Permit Type: Building/Residential/Mech/New  
 Permit Number: M21000878  
 Opened Date: 10/05/2021

Description of Work  
 INSTALL NEW GEOTHERMAL HVAC USING (1) WATER FURNACE 4-TON NDH049 GEOTHERMAL UNIT WITH HORIZONTAL LOOPS (4 TRENCHES, 150' IN LENGTH, 5' DEEP). WE WILL USE EXISTING DUCT.

**MEMORANDUM**

RE: M21000878; Unapproved Installation

**HOUSE LOCATION DRAWING**  
 REMAINDER, SECTION II, LOT 22  
**MATHIS PROPERTY**  
 PLAT NO. 7869  
 LIBER 14411 FOLIO 55  
 12395 FREDERICK ROAD  
 THIRD ELECTION DISTRICT  
 HOWARD COUNTY, MARYLAND  
 SCALE: 1" = 100' NOVEMBER 2016

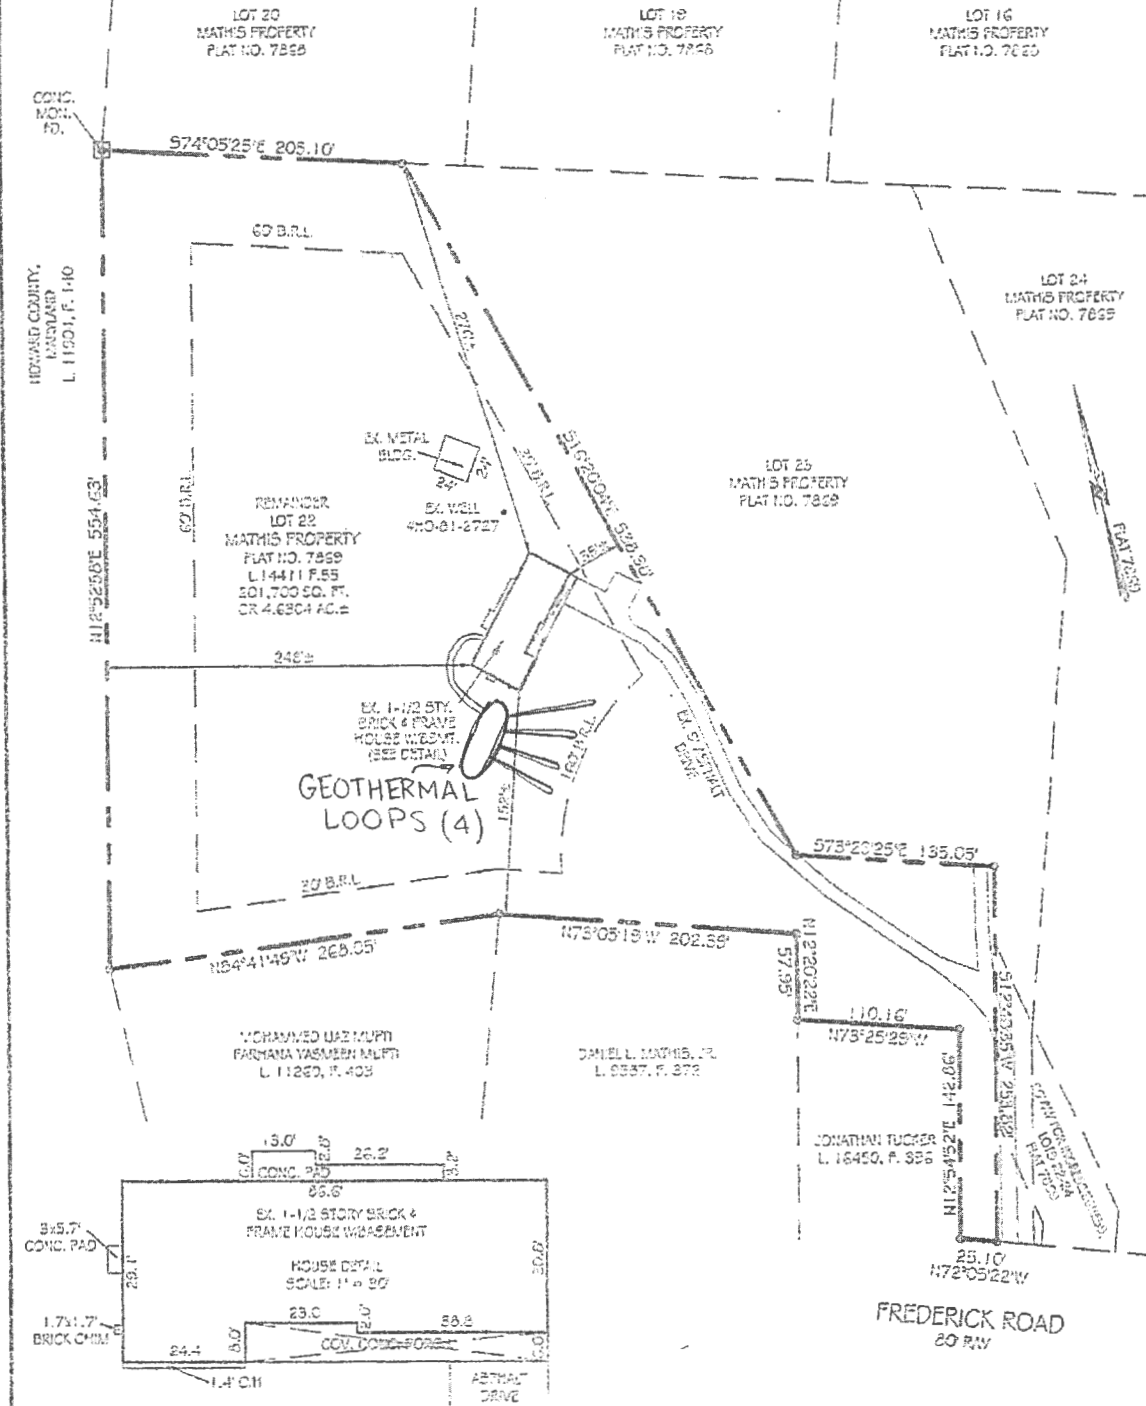
Pursuant to Howard County Mechanical Permit 21000878, be it known that Ground Loop Heating & Air Conditioning, INC, installed four horizontal geothermal loops, approximately one hundred and fifty feet in length each, and did not provide Howard County Well and Septic with a scaled plot plan showing that the horizontal loops did not conflict with existing well and septic setback policy requirements.

**At the time of this memorandum, it is unclear whether the installation impacted the existing well or septic system and it is unclear if the septic reserve area or future repair area was affected.**

Do you have scaled measurements or anything staked in the field for this project? The plot plan submitted appears that the horizontal loops enter the house at the location of the sewer house connection of the sewer line; will these be crossing?

Please resubmit a scaled plot plan showing the existing well septic elements (tank and drainfield) and a scaled plan of the horizontal loops. The plot plan must also show any well and septic elements that are within 100' of the lot line. The hand drawing makes the 150' loops appear to be around 60' and proposed length of 150' trench from the corner of the house as shown will extend the loops into the neighbors yard.

Loops over, in end  
of November

did not cross any  
septic line
